**ES7024-11 (TCM P/N 656872)
ES7024-14 (TCM P/N 657199)
ALTERNATOR FAN AND PULLEY REPLACEMENT**

This Service Bulletin is being issued to mandate the replacement of both the fan and pulley assemblies on the existing ES7024-11 (TCM 656872) & ES7024-14 (TCM 657199) alternators and to announce the availability of an improved pulley assembly which when installed will remedy the above condition.

Figure 1 - Alternator Part Replacement

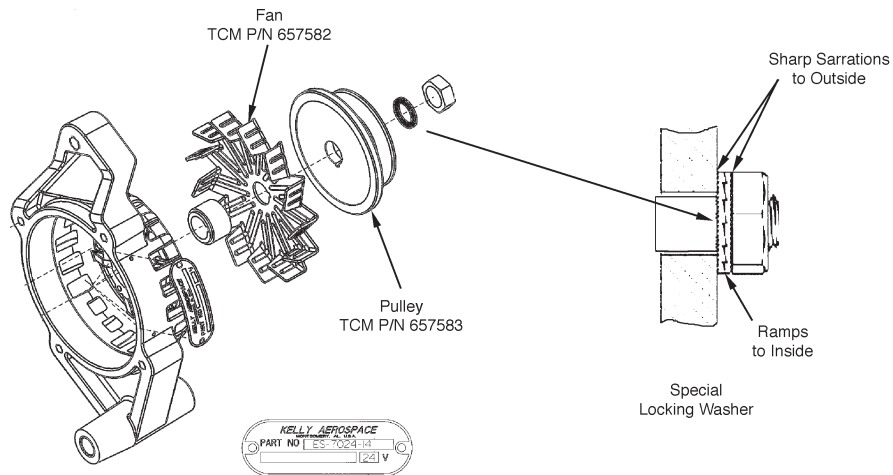
5. Install a new TCM P/N 657582 fan, and new TCM P/N 657583 pulley as shown in Figure 1. Use the existing pulley nut and the locking washer. Take care when removing the locking washer as it is a special device which has two pieces. The sharp serrations must face outward while the shallow ramp must face each other. Using the strap wrench per instruction 4 above, torque the pulley nut to 35 to 45 ft-lbs.
6. Install the alternator belt (new or existing) on to the pulley and tension per instructions contained in the applicable manufacturers maintenance manual.
7. Perform an engine run to check the security and performance of the backup alternator installation and proceed to the "Return to Service" section.

One (1) each, fan, TCM part number 657582, and one (1) each, pulley, TCM part number 657583.
